GROUP Engine	
NUMBER 038

TECHNICAL SERVICE BULLETIN

2.5L/2.7L (DELTA) ENGINE HESITATION / MIL ILLUMINATION / P0123

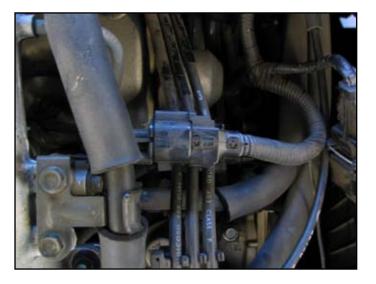
Some 2001-2006 Optima (MS) produced between 10-07-2000 ~ 08-31-2005, equipped with the 2.5L or 2.7L (V-6) Delta Engine and some Sportage (KM) models produced between 10-28-2004 ~ 05/18/2007 equipped with the 2.7L (V-6) Delta Engine are applicable for this bulletin. Improper throttle position sensor values may cause the engine to hesitate under loads or cause the illumination of the MIL. To correct for this condition, the throttle position sensor (TPS) has been improved.

Part Number					
Previous	New				
35170 37100	35170-37100FFF
